SUBJECT: Forwards response to request for addl info re control room  
 habitability evaluation.Attachment A to ltr describes 900919  
 event & design mods planned. ✓

Subject: Duane Arnold Energy Center  
Docket No: 50-331  
Op. License No: DPR-49  
Response to Request for Additional  
Information Regarding DAEC's Control  
Room Habitability Evaluation  
Reference: Letter, C. Shiraki (NRC) to L. Liu (IELP)  
dated August 2, 1991  
File: A-107a

## RESPONSE TO REQUEST FOR ADDITIONAL INFORMATION

CONTROL BUILDING VENTILATION  
(Simplified)

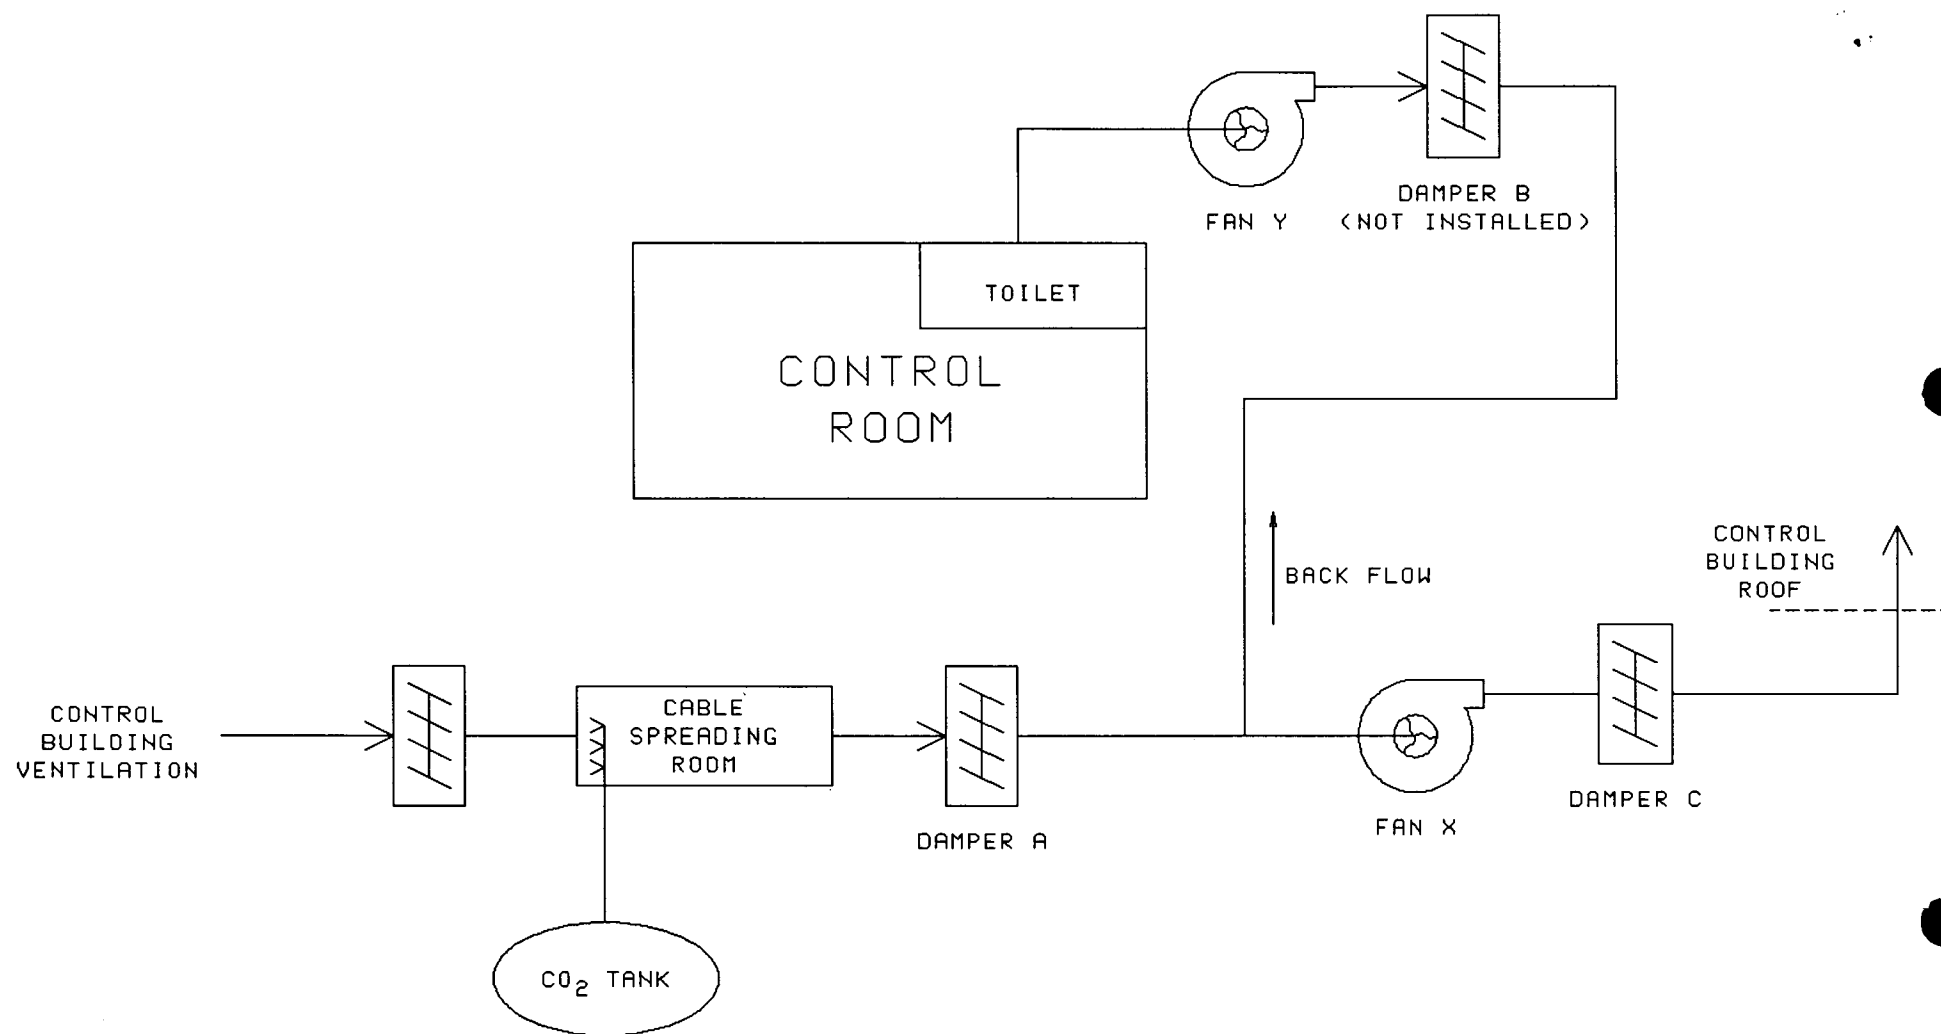
The modifications to the ventilation system were completed in May 1974. Additional fire dampers were installed in the Cable Spreading Room and the CO<sub>2</sub>-actuated logic on the room exhaust damper (see Damper A Attachment B) was replaced with 360 degree F fusible links. The exhaust damper would then remain open until the fusible links sensed an actual fire (360 degrees F) thereby maximizing the availability of a vent path to prevent overpressurization of the Cable Spreading Room.

It was during the investigation of the September 19, 1990, event that we identified that the backdraft damper (see Damper B) which was intended to prevent air from backflowing into the Control Room from the Cable Spreading Room was never installed. Design documentation has always reflected a damper in the line and consequently, its presence was assumed in the later habitability evaluations. Despite vigorous efforts, we are unable to explain its absence. Additionally, we determined that upon CARDOX actuation, the room exhaust fan (see Fan X) secures and the fan's discharge damper (see Damper C) closes, effectively blocking the intended vent path. Therefore, the 1974 ventilation modifications were ineffective in that a CARDOX initiation can still pressurize the Cable Spreading Room and, without the backdraft damper, CO<sub>2</sub> can backflow into the Control Room.

Design modifications have been initiated which will address the backflow through the control room exhaust fan (see Fan Y) and ensure the proper venting of the Cable Spreading Room in the event of a CARDON initiation. These design changes will be complete prior to shutdown for the Cycle 11 refueling outage. Additionally, post-modification testing will be performed during the Cycle 11 outage to verify the effectiveness of these modifications. Upon successful completion of this testing, the Control Room habitability evaluation described in UFSAR Section 6.4 will be revised to reflect the analysis of and corrective actions resulting from the September 19, 1990 event.
